Rezoning Transportation Analysis

Petition Number: #2022-048

Date	Description
08-25-22	First Review (PDM)
09-22-22	Second Review (PDM)
10-27-22	Third Review (TM)

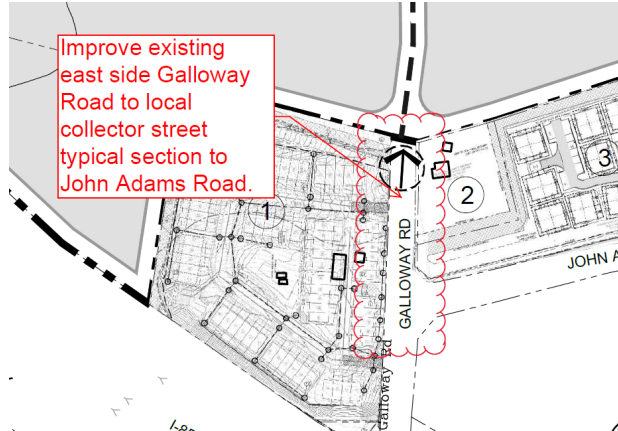
A Traffic Impact Study (TIS) is necessary for the complete review of this petition due to the site generating more than 2,500 daily trips. The petitioner submitted the Draft TIS Scoping Package on February 15, 2022, and CDOT provided comments on the Scoping Package on March 1, 2022. The Draft TIS was submitted to CDOT on 9/20/22, and is currently under review by CDOT.

Staff will receive the petition and begin review, but the public hearing will not be scheduled until the TIS is approved to allow for the minimum time necessary for CDOT to review the study and reach agreement with the petitioner on the required transportation commitments. Any agreed upon commitments shall be included on the last site plan submitted no fewer than 4 weeks prior to the public hearing. Therefore, additional traffic mitigation comments may be forthcoming once the TIS is approved by CDOT (and NCDOT).

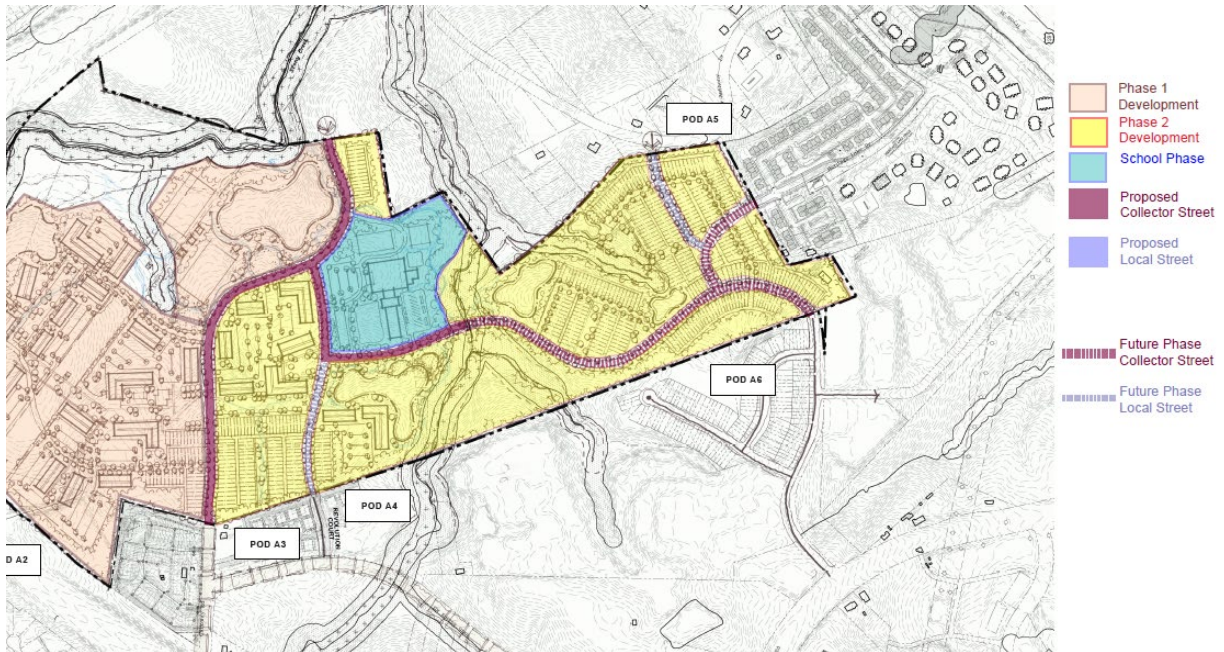
~~2. **Outstanding Comment from 08-25-22:** Revise site plan and conditional note(s) to commit to improving the existing Galloway Road stub to John Adams to the local collector street typical section per U-07.~~

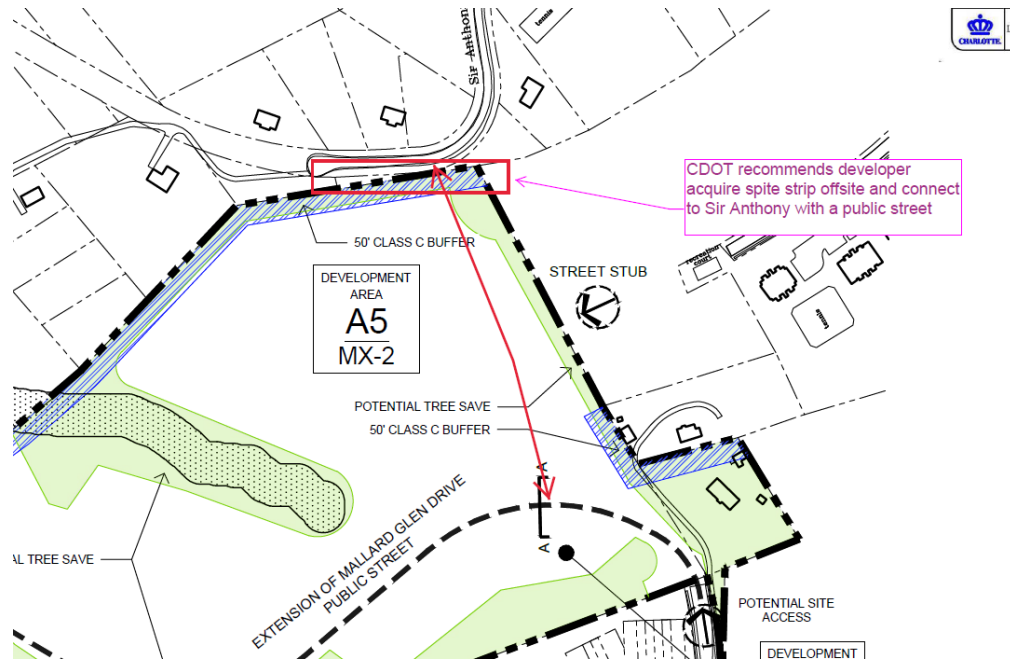
- ~~4. Add conditional Lighting Note for petitioner to coordinate with CDOT Lighting, Bruce Horltd (704-589-5836 or Bruce.Horltd@charlottenc.gov), prior to permitting of lighting fixtures on public roadways.~~
- ~~5. **CDOT RECOMMENDATION:** CDOT recommends the petitioner commit to providing a public street connection to Sir Anthony Drive.~~
